Technical note

Project	001291 Sunshine Coast Airport PDA Master Planning		
From:	BMT		
Date:	06/08/2026	To: SCA	Sunshine Coast Airport (Simon Kay)
Doc Ref:	M.001291.005.01		
Subject:	Gateway Precinct Masterplan Flood Mitigation

Figure 1 Comparison of 1% AEP Gateway Mitigated Flood Impacts (Local Model)

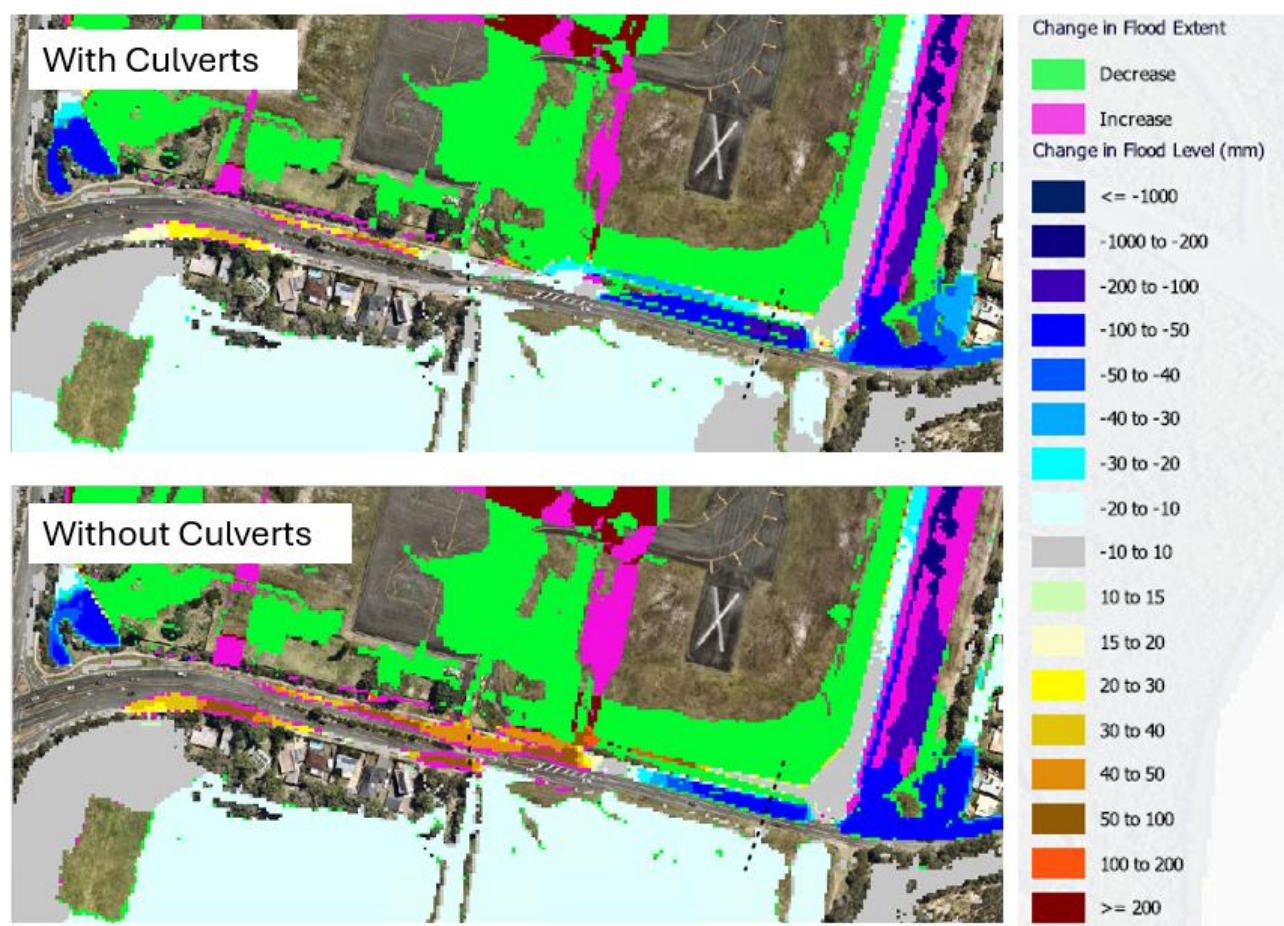
Items 8 and 9 are culvert upgrades under David Low Way. It is proposed to undertake these works as part of the David Low Way upgrade to ensure that the culverts integrate with the road design. BMT has undertaken modelling simulations of the Gateway development with the flood mitigation items included except for Items 8 and 9. The resulting flood impacts have been compared to those reported in the Gateway Precinct FIA (which includes Items 8 and 9). The comparison has been undertaken for the 1% AEP event using the local model, as the need for these mitigation features was identified using the local model.

Figure 1 shows the comparison for the 1% AEP. The locations of the culvert upgrades are shown with a dashed line. From Figure 1 it can be seen that the simulation without culvert upgrades (lower image) shows increased impacts adjacent to David Low Way. These impacts are localised and are within the David Low Way corridor. When the 1% AEP flood levels in the EPD are compared, there is less than a 5mm difference in peak flood level between the developed case model with the culverts and the developed case model without the culverts.

Overall it is concluded that the flood mitigation items incorporated by EGIS into the Gateway design (Items 1,2, 6 and 7) adequately replicate those documented and tested in the Gateway Precinct Masterplan FIA. Items 8 and 9 (culvert upgrades under David Low Way) are not included in the design. BMT understands that these items will be undertaken as part of future David Low Way works. A sensitivity test in which the Gateway Precinct development and associated flood mitigation was simulated without these culvert upgrades was undertaken and demonstrated that the resulting increases in impact were localised to the David Low Way corridor. Given that David Low Way is to be upgraded as part of the overall PDA, BMT considers it appropriate that these culvert upgrades are undertaken as part of the David Low Way upgrade. This will ensure that the culvert upgrades can be integrated and optimised to allow for any changes to runoff resulting from the David Low Way upgrade.
